HILLSIDE ESTATES SUBDIVISION

APPLICATION NUMBER 16 DATE June 19, 2003

REQUEST Subdivision

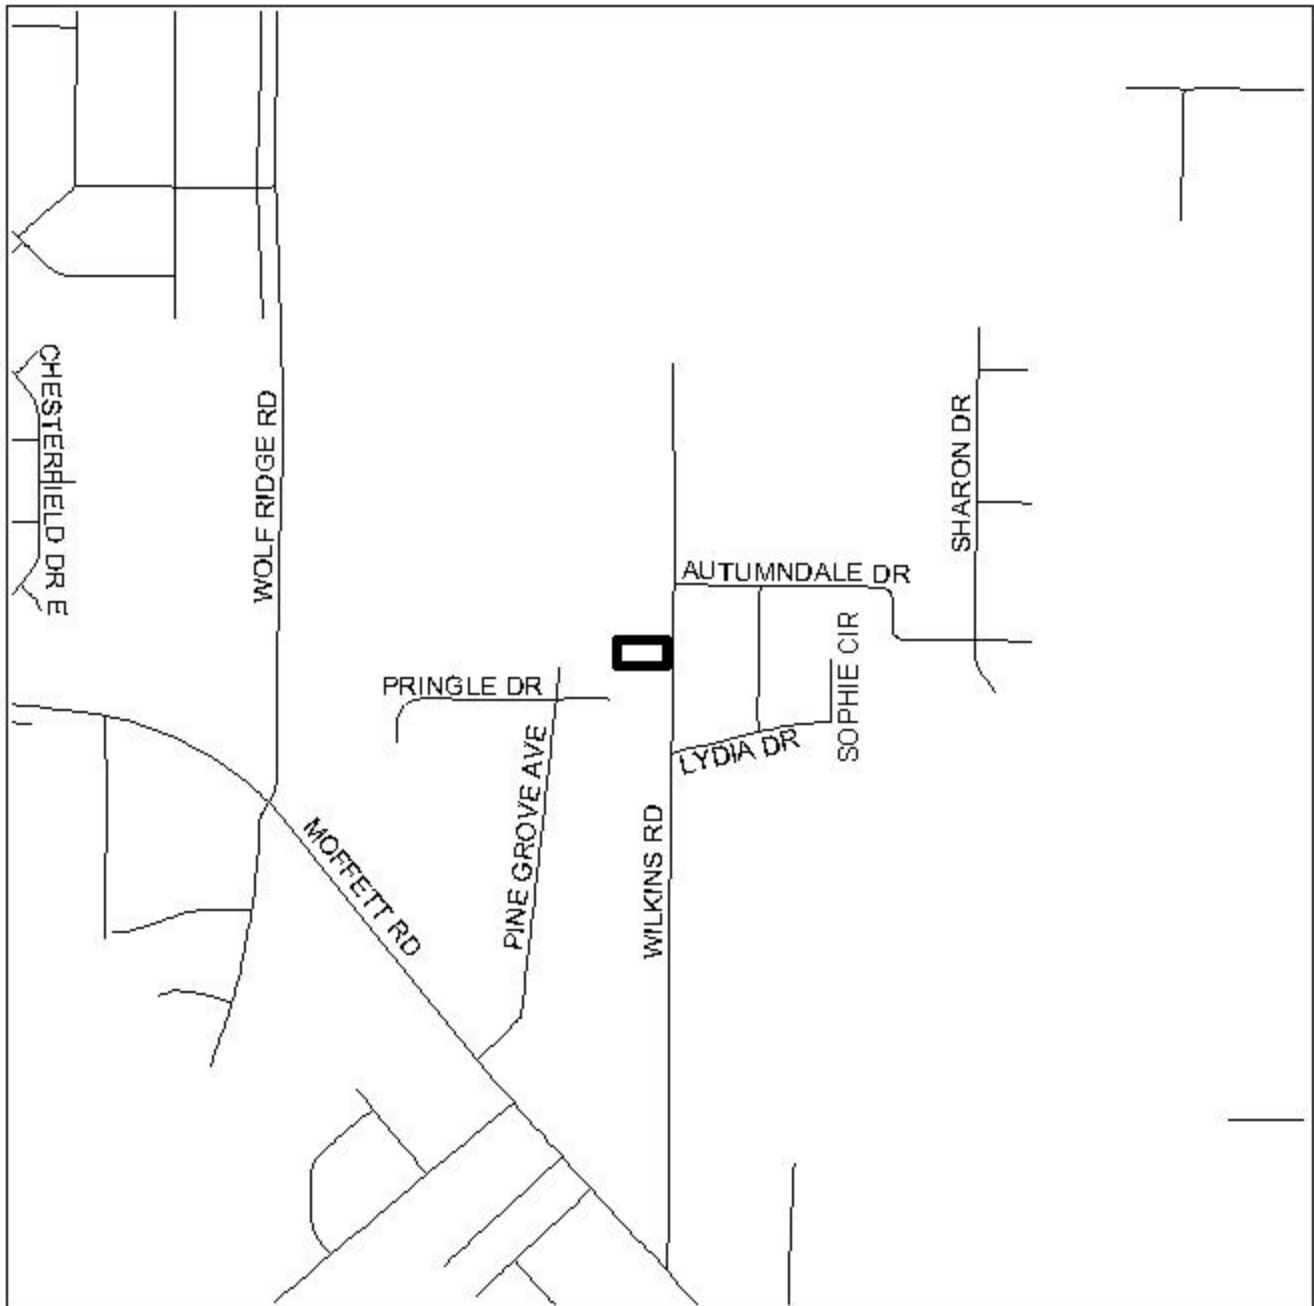
Engineering Comments: Must comply with all stormwater and flood control ordinances. Any work performed in the right-of-way will require a right-of-way permit.

Traffic Engineering Comments: Driveway numbers, size, location and design to be approved by Traffic Engineering and conform to AASHTO standards.

The twenty-five foot minimum building setback lines are not illustrated, but would be required on the final plat.

Lot 1 is limited to one curb cut to Wilkins Road, with the size, location and design to be approved by the Traffic Engineering Department.

The plat meets the minimum requirements of the Subdivision Regulations and is recommended for Tentative Approval subject to the following conditions: 1) the placement of the 25-foot minimum setback line on the final plat; and 2) the placement of a note on the final plat stating that Lot 1 is limited to one curb cut to Wilkins Road, with the size, location and design to be approved by the Traffic Engineering Department.
